Cloud-Aerosol LIDAR and Infrared Pathfinder Satellite Observation (CALIPSO) Spacecraft

Independent Technical Assessment

NASA Engineering and Safety Center Report	Document #: RP-04-01/ 03-001-E	Version: 2.0
Title: CALIPSO Independent Technical Assessment/Inspection (ITA/I) Report		Page #: 1 of 181

Figure 2. MS 33656 A/N fitting installation detail

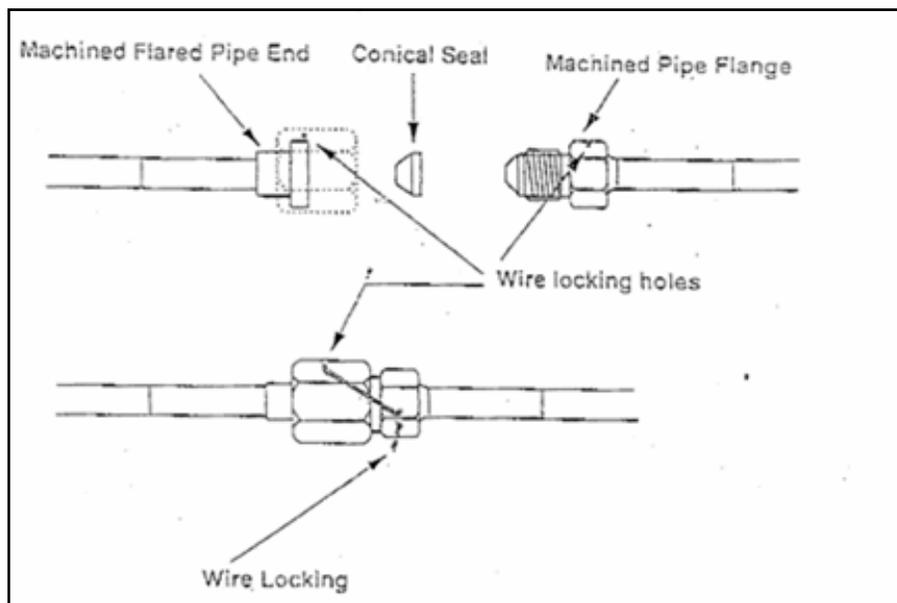
Properly welded fluid connections are inherently more reliable than mechanical fittings and should be incorporated in fluid propulsion system designs when possible. There are some circumstances, however, under which mechanical fittings offer an appropriate design solution. Ready interface to off-the-shelf parts, ease of maintenance, or potential for damage to soft goods during welding all may dictate use of threaded joints. MS-33656 type 37° A/N-fittings have been employed successfully in aerospace applications for many years and are acceptable for limited use providing they are (1) properly assembled, (2) validated by leak check as an assembly before use, (3) exposed only to temperature, pressure, vibration and shock environments for which they are certified, and (4) incorporate a secondary locking feature. The Proteus bus uses five such fittings; one at the hydrazine tank outlet and one at each of the thruster inlets (see Figures 2 and 3 for details). While lock-wire is used as a secondary locking feature, it is suitable only for preventing significant rotation of the B-nut and full disengagement of the fitting. Lock-wire alone will not prevent loss of joint preload⁸ with subsequent reduction of clamping force at the sealing surfaces, and thus cannot be counted upon to prevent a fitting from leaking.

Figure 4. Moog Dual Seat Dual Servo Thruster Valve

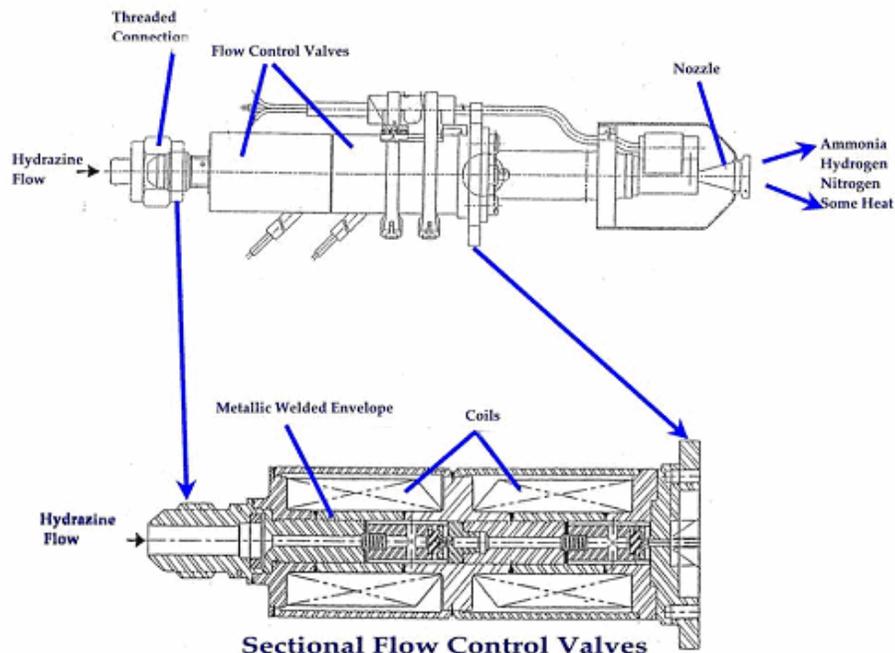
NESC concludes the potential for external leakage from the thrusters either internally (across the control valves) or externally (thruster casing or seal) poses acceptable risk to personnel providing the program conducts an adequate pre-servicing leak check of each valve. While the program did indicate such testing was planned, NESC was not provided a specific description of the test or its pass/fail criteria.

During a site visit to Aerojet Space Propulsion, an issue with Moog thruster valves similar or identical to the Proteus valves came to light. A manufacturing process change by Moog resulted in a recall investigation on suspect serial number valves²¹. The program was notified of this and was working to clear the CALIPSO Proteus bus valve set.

NESC-R-008 Program shall verify that the Proteus Moog valves on CALIPSO do not have defective plunger assemblies.

Figure 5. Thruster Circuit Schematic with New Test/Arm Plugs (PM refers to spacecraft processor module)

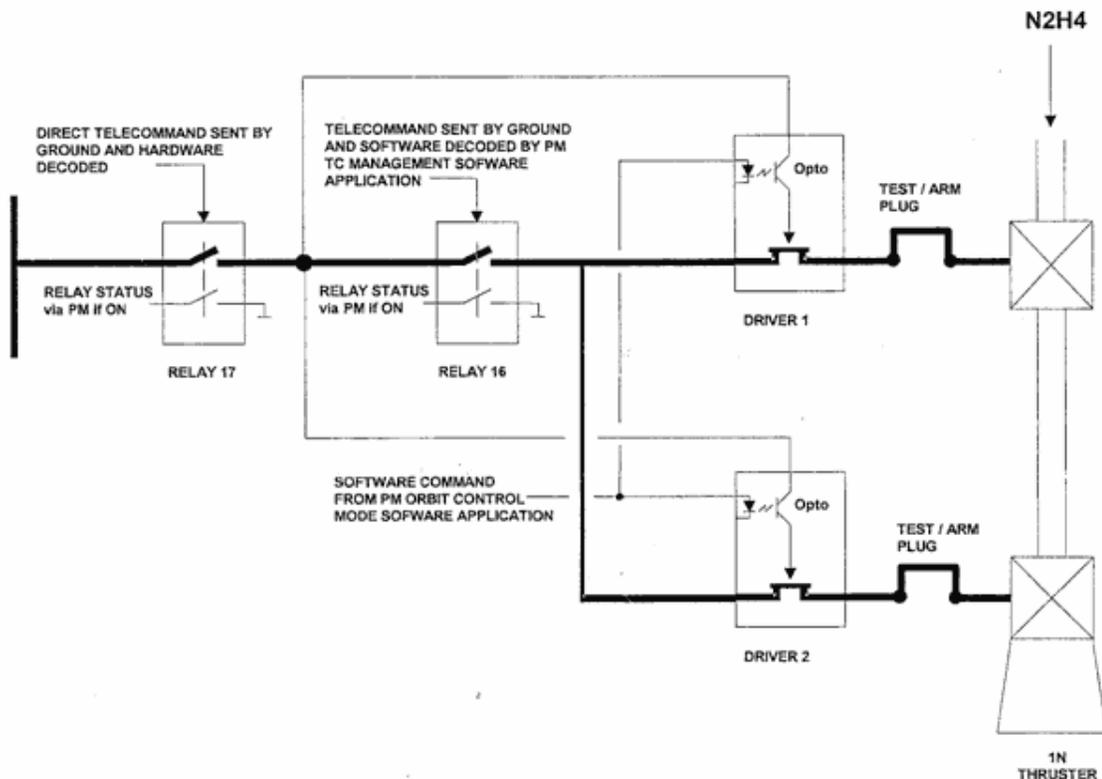
The Proteus thruster firing circuit incorporates a number of controls to ensure valves are not inadvertently opened causing a thruster to fire. NESC concurs the controls are adequate, but recommends further steps be taken to positively preclude the possibility of an inadvertent command during periods of dynamic testing, especially power-up. A schematic of the thruster wiring circuit is shown in Figure 5. It is worth noting that the Astrium specification sheet for the thruster lists nominal flow rate at 0.44 grams per second. Even with all four (4) thrusters firing at nominal flow rate, it would take 4.7 hours to drain the 30 kilograms of hydrazine in the propellant tank.

NESC-R-009 – Program shall demonstrate that test procedures verify relays 16 and 17 are open before power is applied to the spacecraft. Since the design incorporates latching relays, verification of the last stable state by data retrieval or written record is acceptable.
